VILLAGE PLAN COMMISSION AGENDA

Village of Kimberly Request for Plan Commission Recommendation

ITEM DESCRIPTION: Site & Architectural Review – Freedom Fellowship Church located at 724 S Railroad Street

INTERIOR / EXTERIOR ALTERATIONS FREEDOM FELLOWSHIP

SITE PLAN

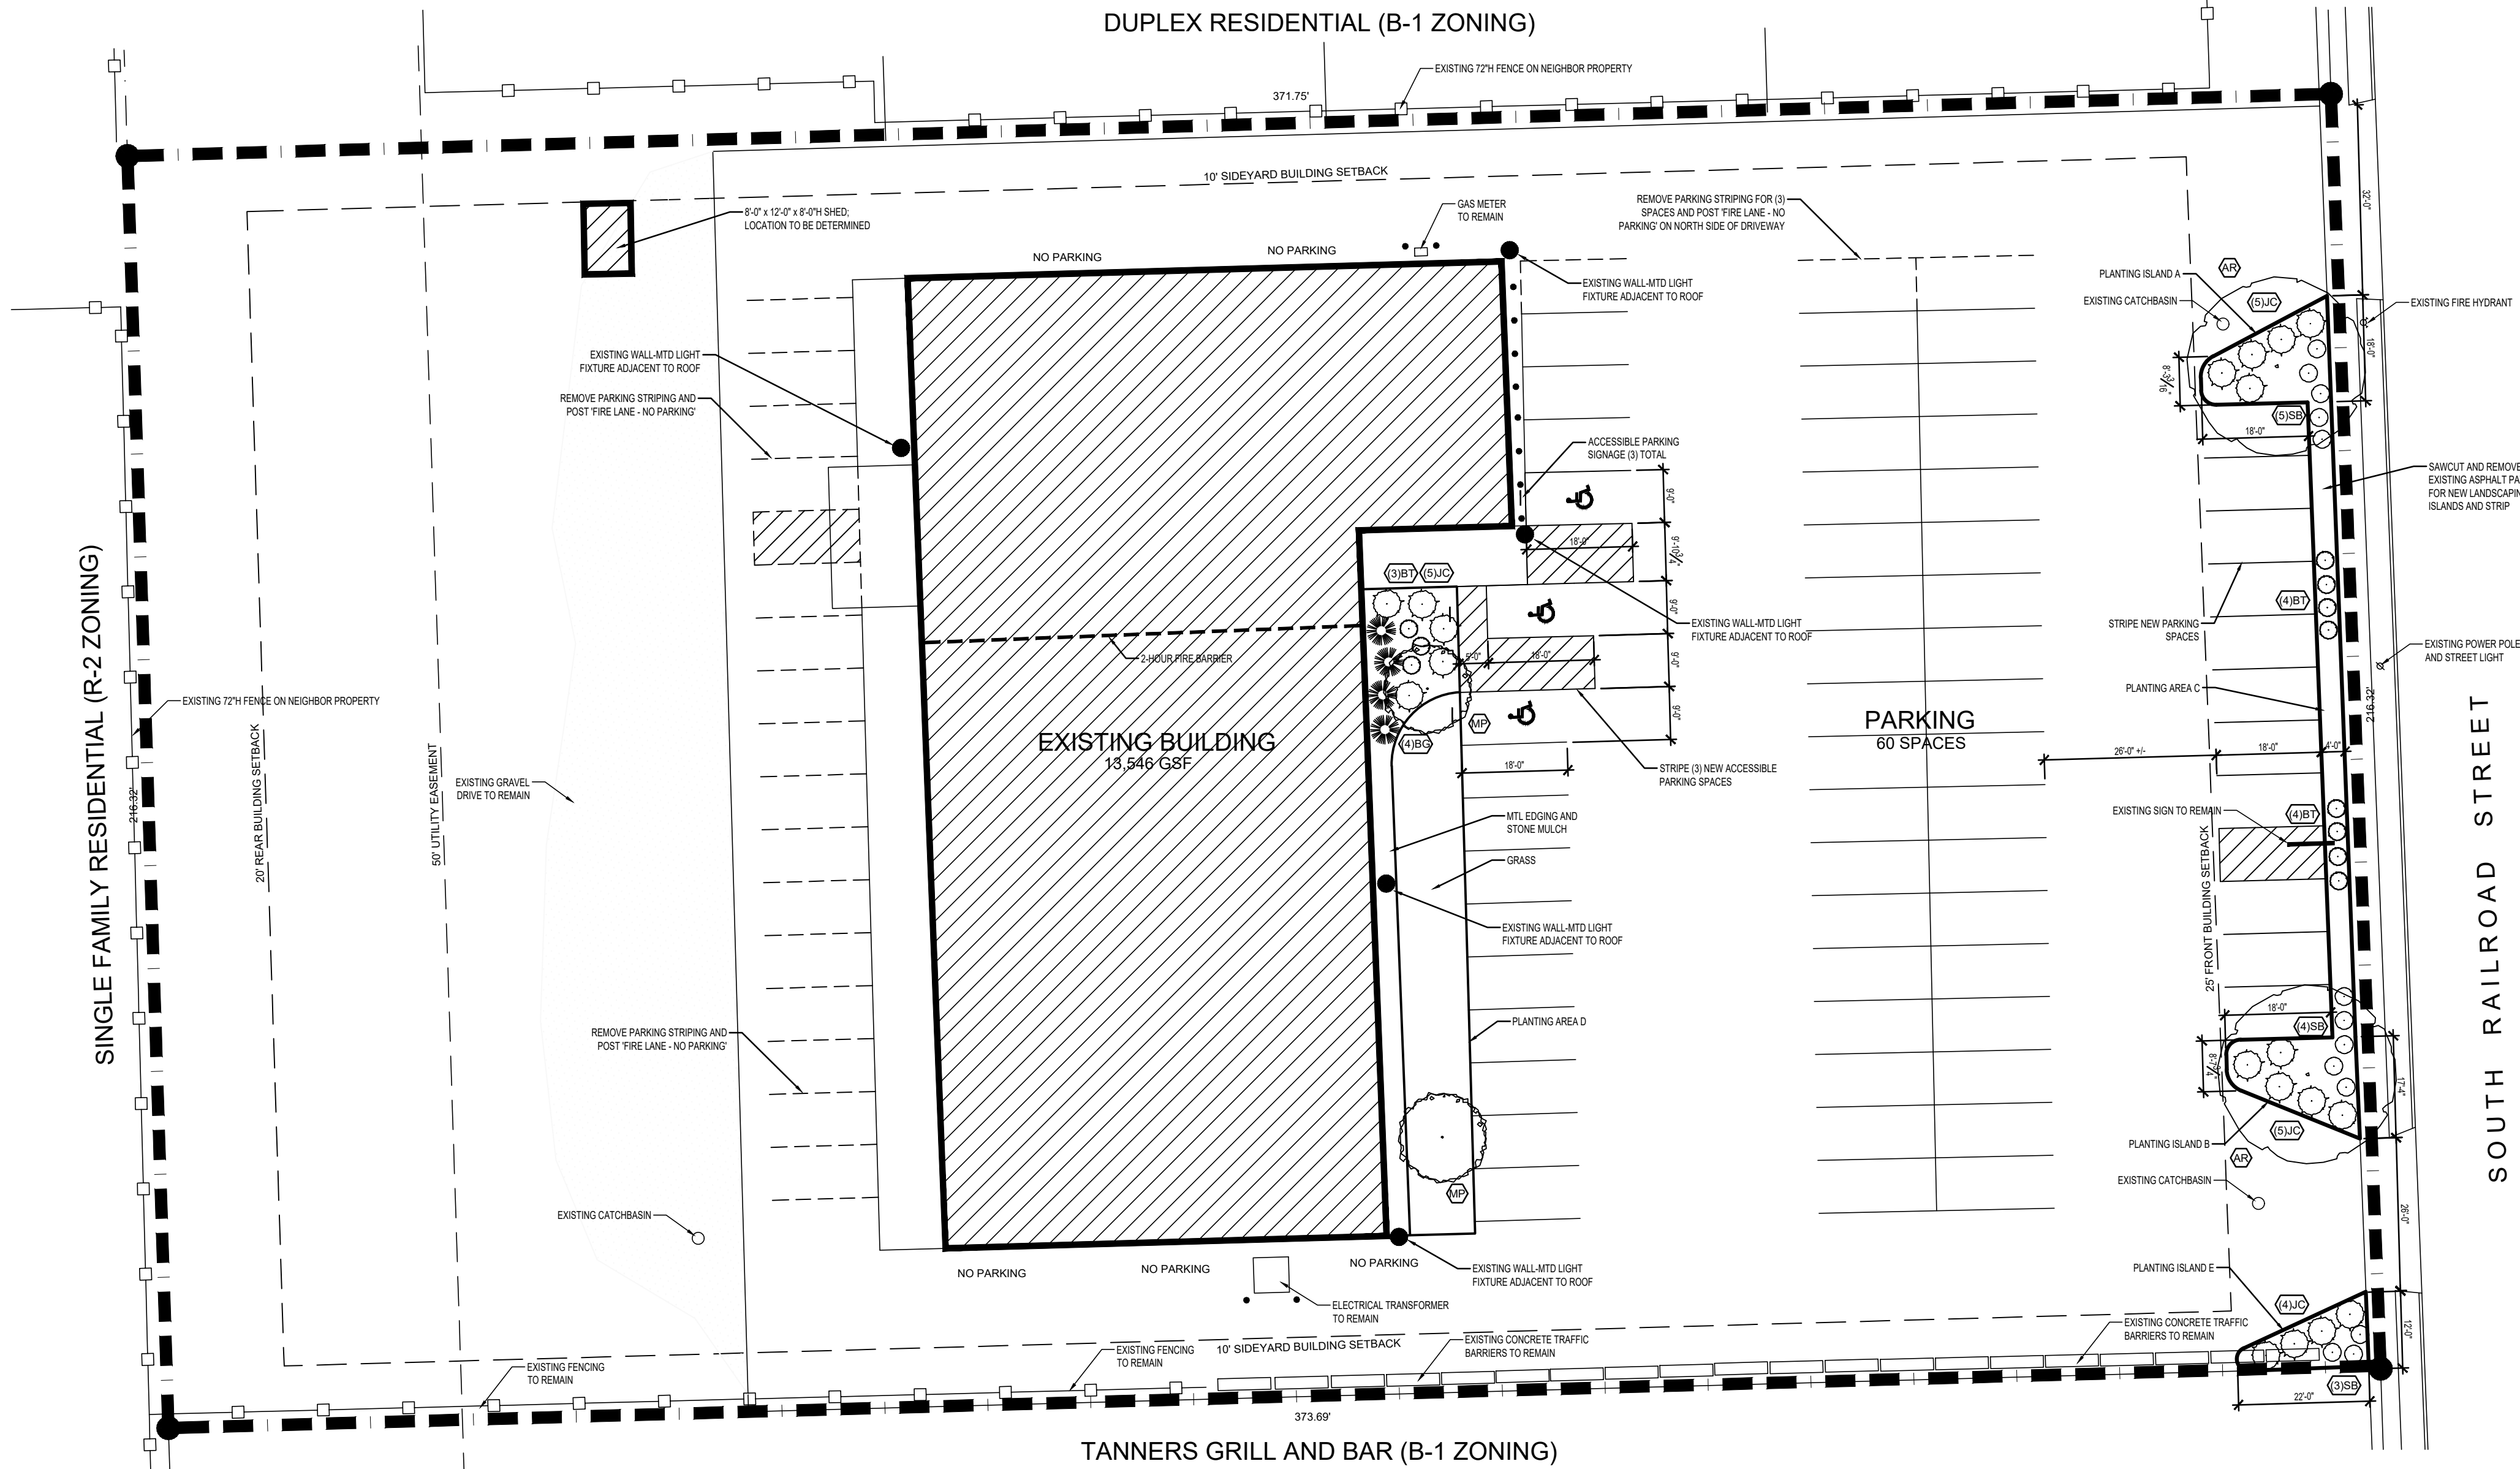
3. **Fire and Emergency Access.** The Village Fire Department has reviewed the proposed plans and noted that the three northern most parking stalls on the east side of the building will need to be removed or striped accordingly to avoid parking within the fire lane. The Fire Department also recommended removing all of the parking stalls west of the building to provide access to the rear of the building in case of a fire. They had noted without specifications on the gravel or this area being hard surfaced, the Fire Department would not maneuver a fire truck beyond the asphalt. These stalls are noted as being removed on the plan set.

4. **Lighting.** The Applicant has noted no change to the existing lighting with just a change of light bulbs. These existing fixtures have an exposed bulb, are in close proximity to residential and have the potential of exceeding the maximum footcandles at the property line. Due to the concerns of the proximity to residential staff is proposing new full cutoff fixtures shall be installed and meet the requirements of the Village Ordinance.

5. **Parking/Landscaping.** The proposed landscaping plan is a great improvement as to what is currently on the premise. At this point nothing is finalized between the Applicant and the neighboring property to the south. However, should future access be provided, further review by the Village and a cross-access easement would be required.

6. **Dumpster.** The proposed plans do not indicate any location for exterior refuse. Staff recommends that any dumpster pad or refuse location be located in the rear of the building and not visible to offsite view.

RECOMMENDED ACTION: Staff recommends approval of the site plan and architectural components for Freedom Fellowship Church located at 724 S Railroad Street as presented, contingent upon the following:

1. Parking is not permitted in the grass or gravel areas in the rear of the building. Any expanded parking beyond paving the gravel area for traffic flow, would require additional review. Furthermore, any future access between 724 S Railroad Street and the property to the south shall require review by the Village of Kimberly.
2. New outdoor lighting shall be installed within six months of occupancy and shall be full cutoff and meet Village ordinances.
3. Any future accessory structures shall meet ordinance and shall be submitted to the Village of Kimberly for approval.
4. Any dumpster or refuse shall be enclosed and out of view from off premise and shall be located in the rear of the building.

EXTERIOR ELEVATIONS

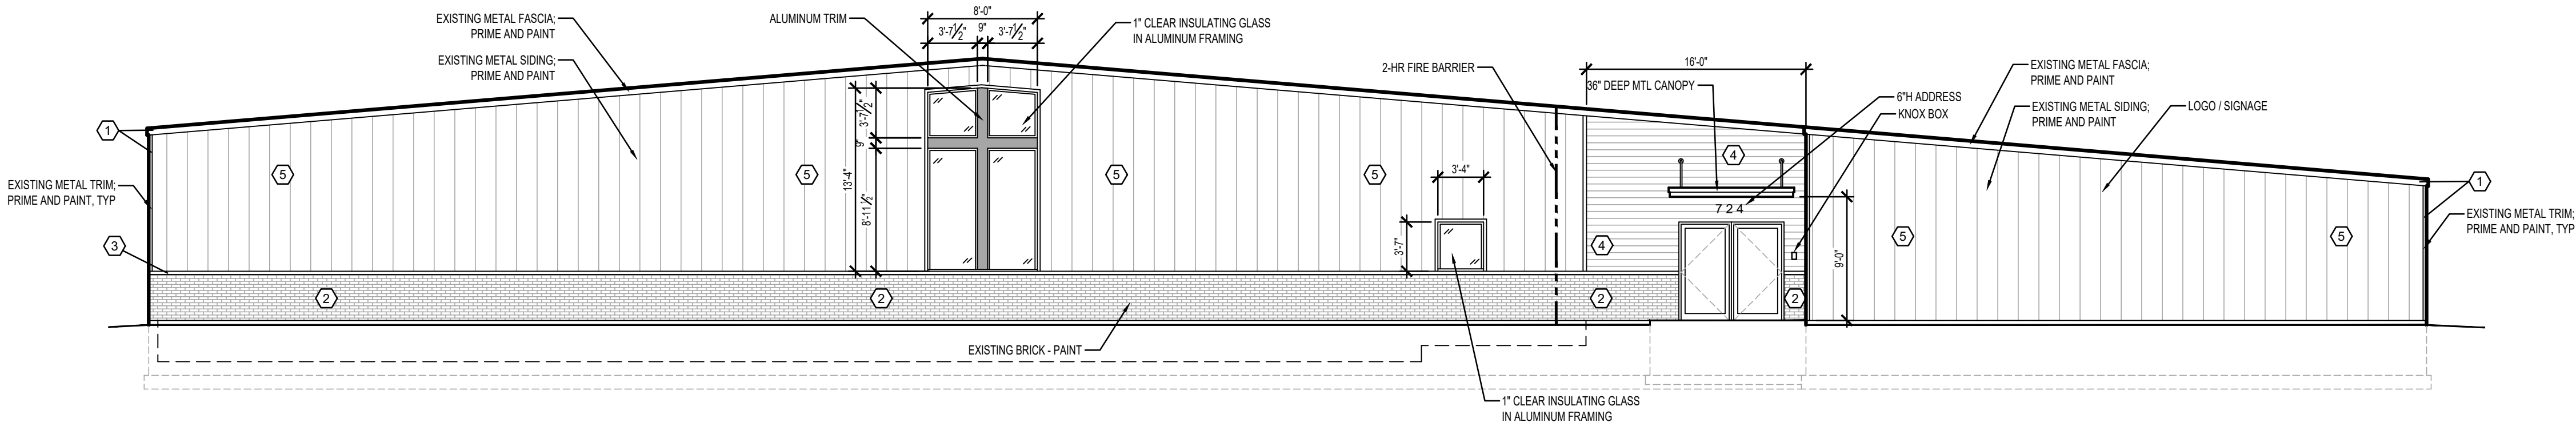
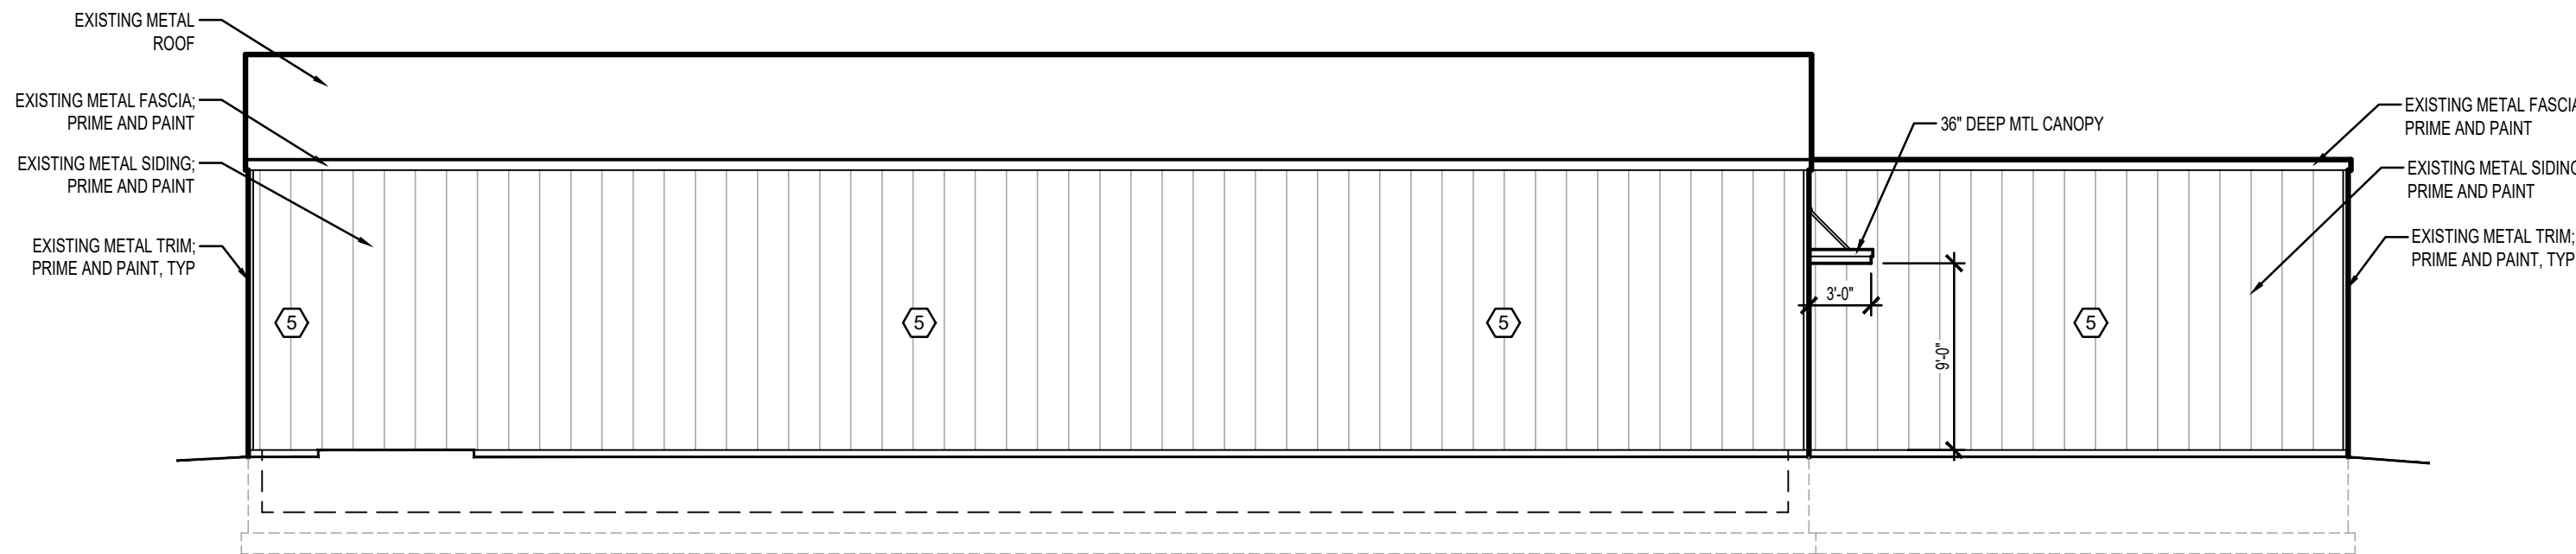
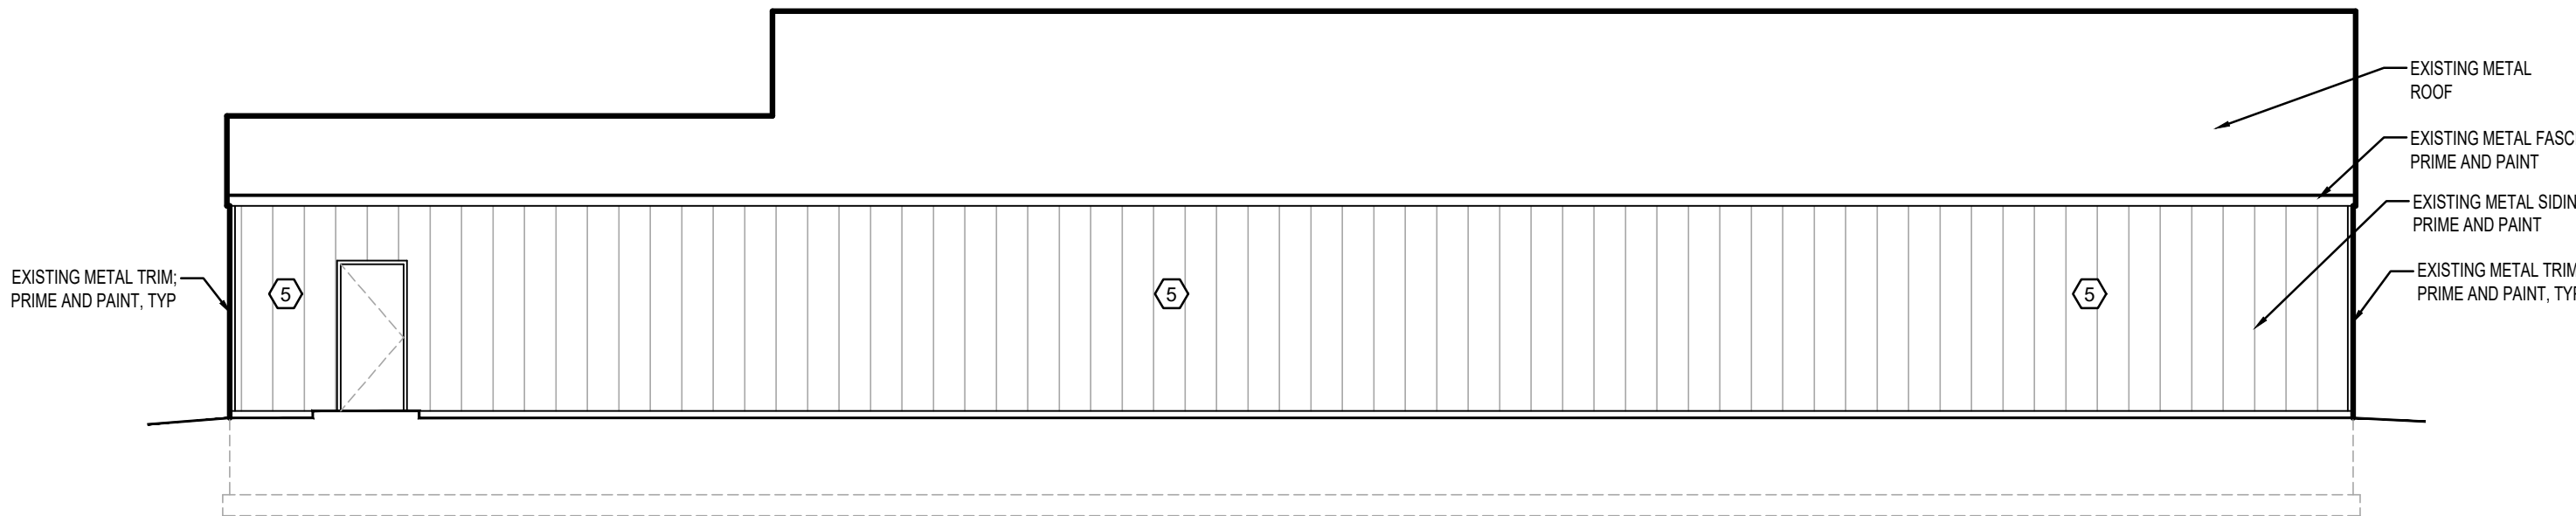
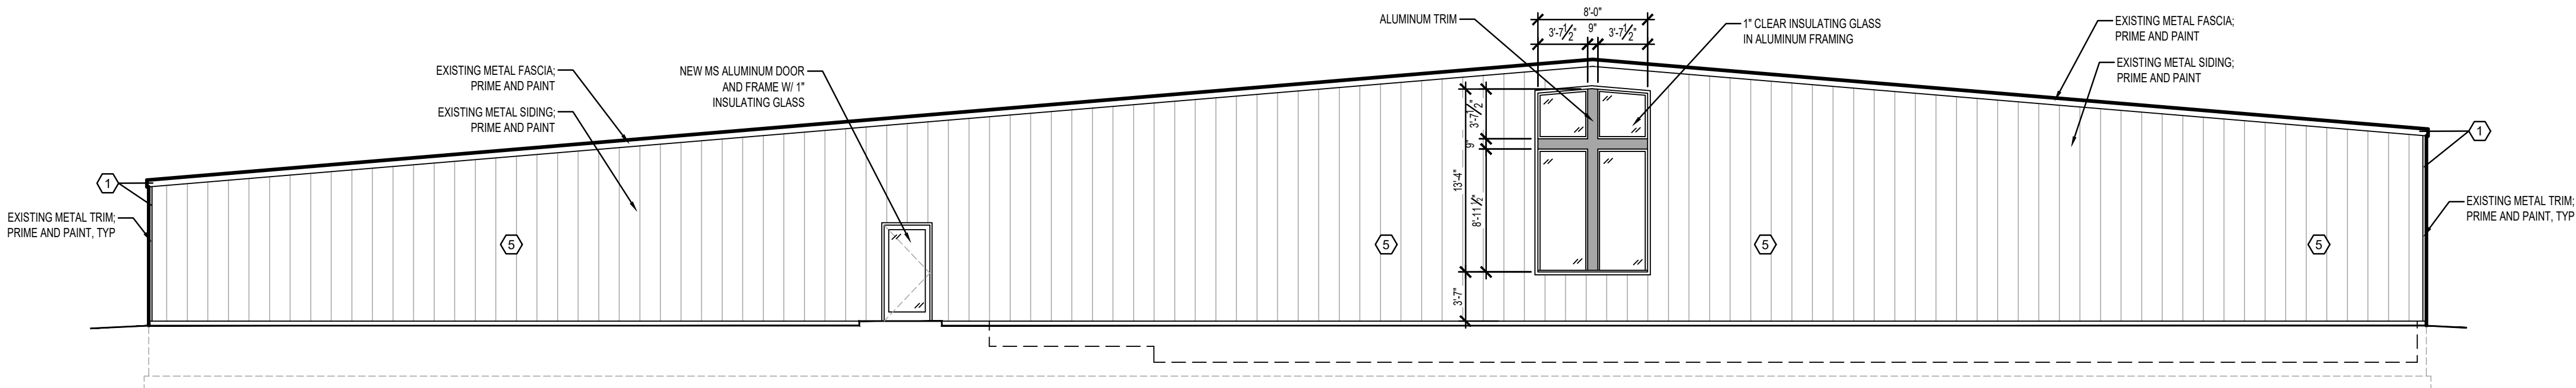
1. 13,546 square foot church and religious assembly facility including a new 2-hour fire wall
2. Improved exterior – paint the existing façade and enhance the front entrance.
3. 61 total parking stalls – gravel in the rear to remain
4. Existing fencing/jersey barriers to remain
5. Add landscaping to the front of the building and landscape islands at the front entrances of the parking lot.
